Subject: Transmittal of Revision 4 to Service Bulletin No.V2500-ENG-79-0051

ENGINE - OIL - TO INTRODUCE A NEW MAIN SCAVENGE OIL PUMP FEATURING
IMPROVED SPACERS AND COVERS

V2500-ENG-79-0051

FIGURE 1

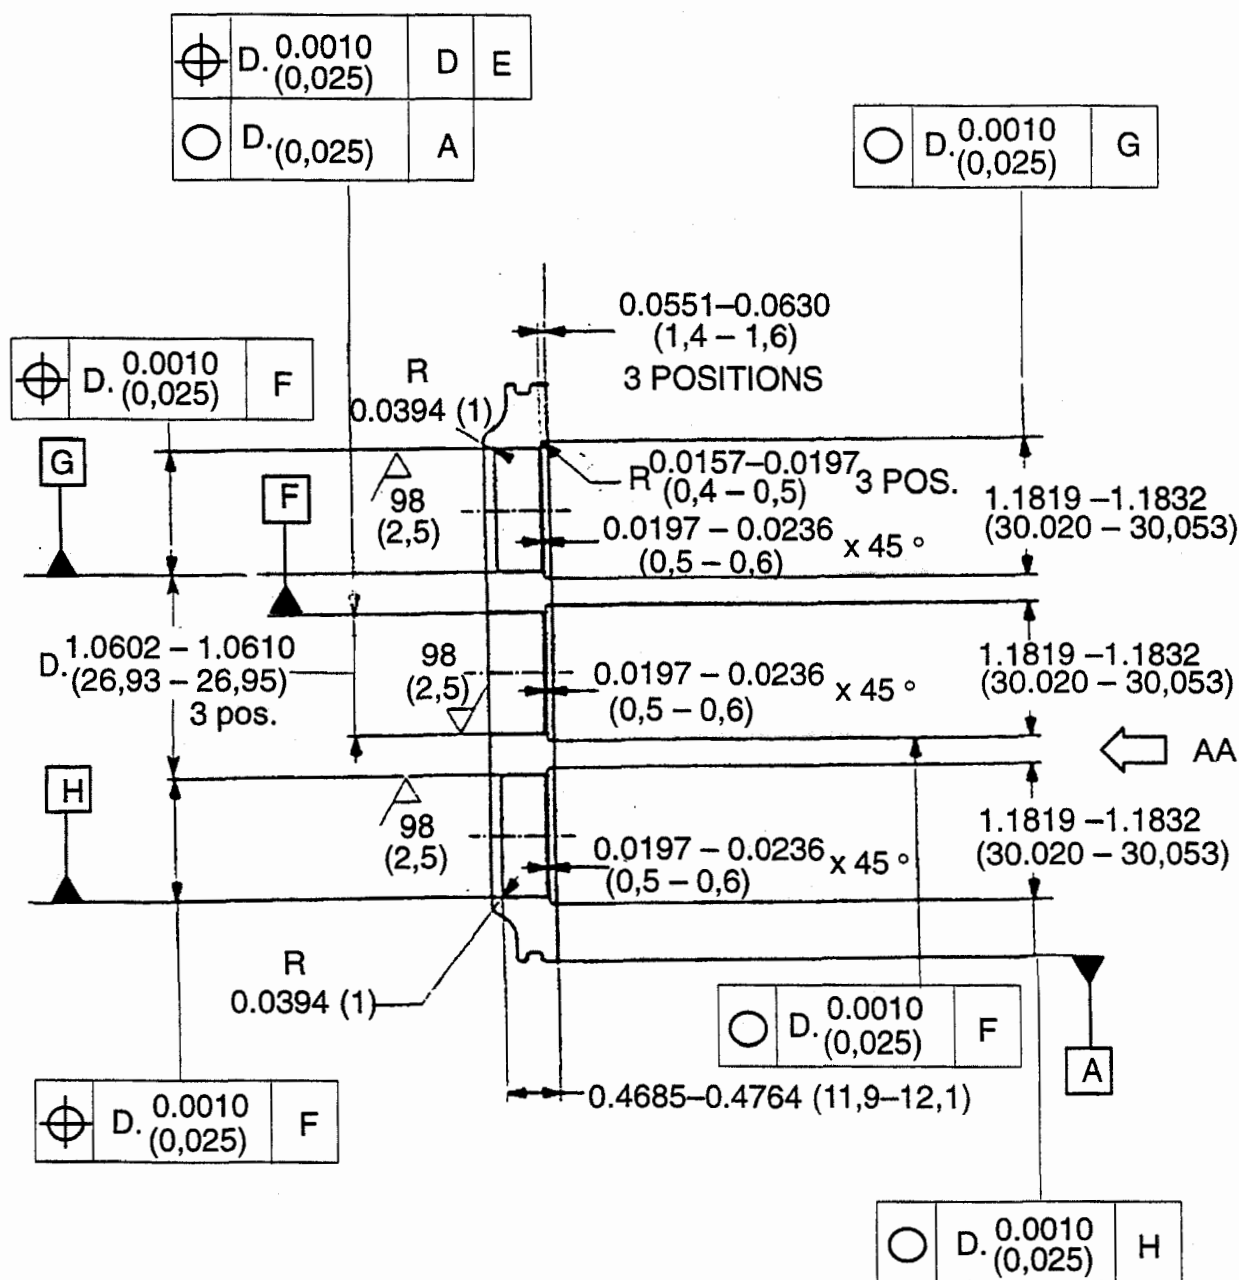
- (i) Machine the bushes inner diameter and grooves

Refer to Figure 1 and 3

FIGURE 3

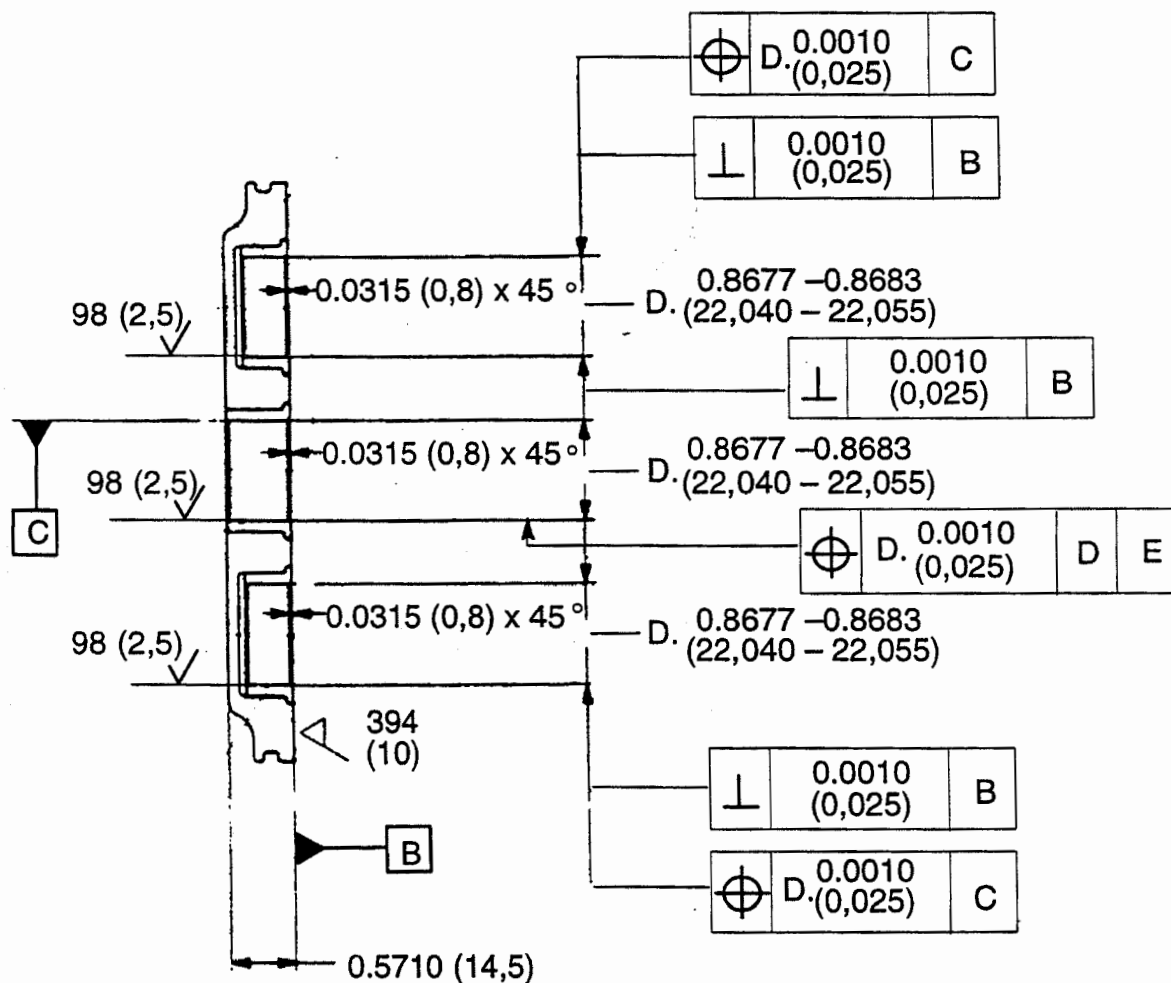
- (g) Lubricate the machined bores and install the bushes P/N 4P7323 (2 off) and P/N 4P7324 (1 off)

Use CoMat 10-077 approved engine oil. Refer to Figure 3

FIGURE 4

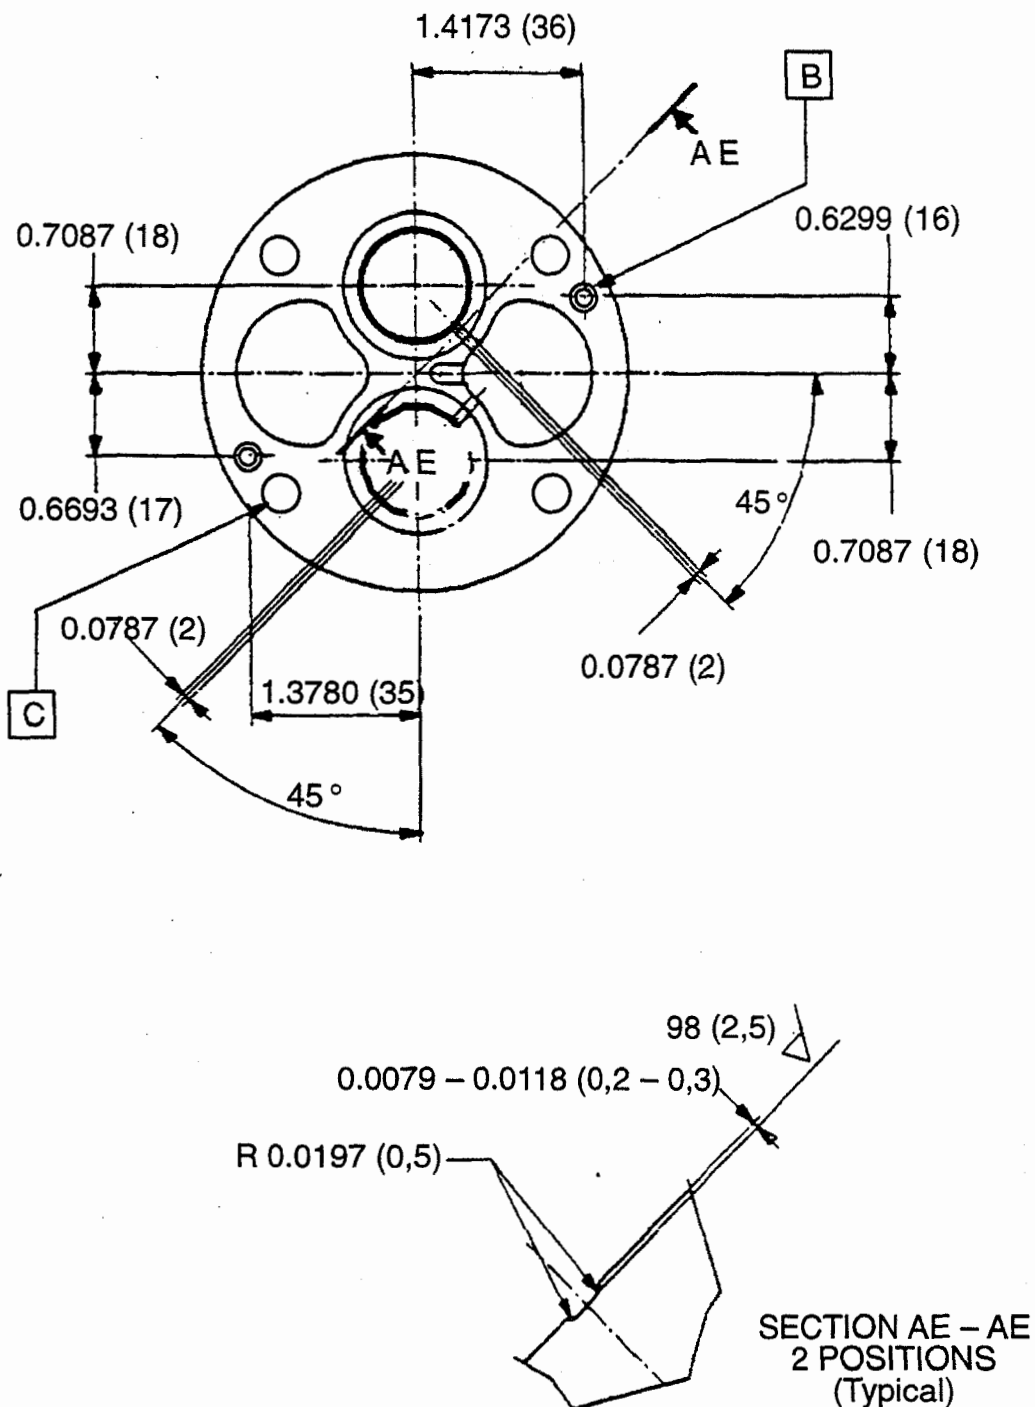
- | | | | | | | | | | |
|---|---|----------------|----------------|--------|--------|---|--|--------------------------------|--|
| (i) Machine the bushes inner diameter and grooves | Refer to Figure 4 and 6 | | | | | | | | |
| (j) Cancel the old part number and identify with the new part number. |

FIGURE 6

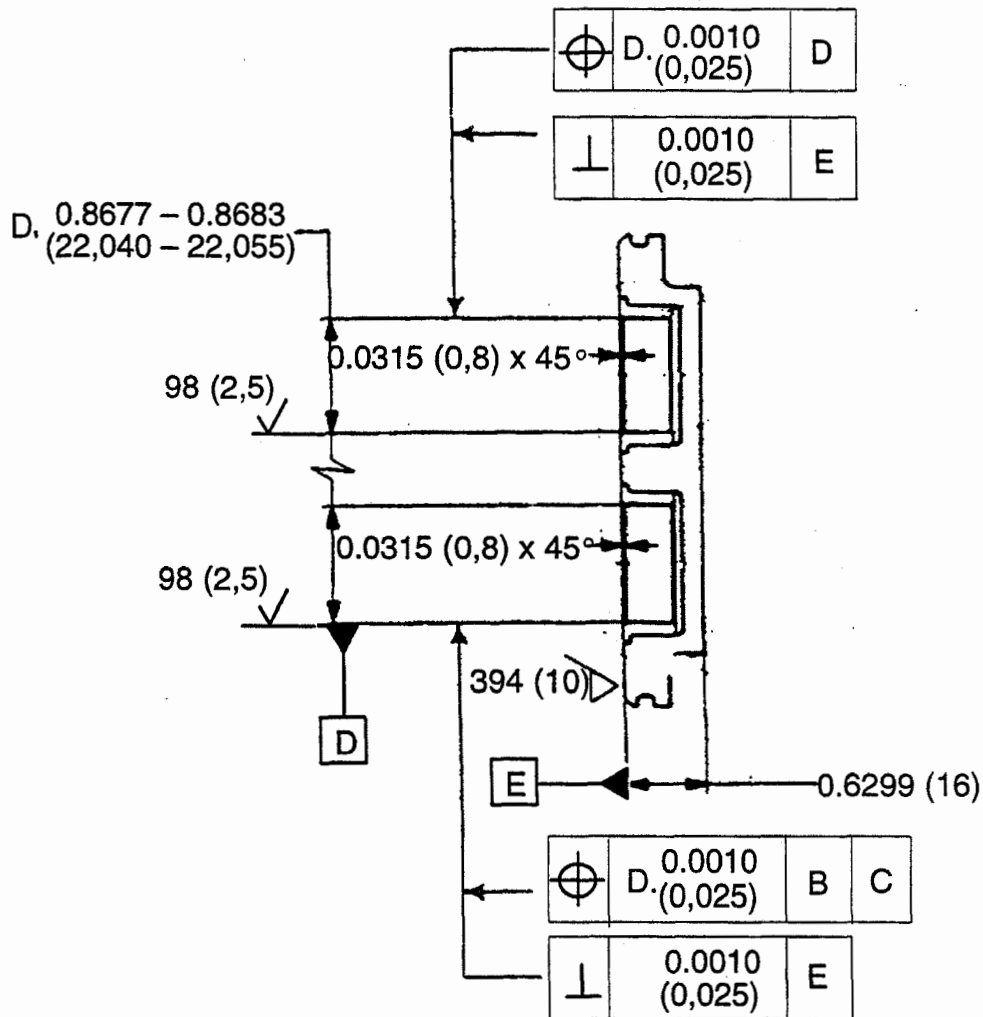
- (g) Lubricate the machined
bores and install the
bushes P/N 4P7323 (2 off)

Use CoMat 10-077 approved en-
gine oil. Refer to Figure 6
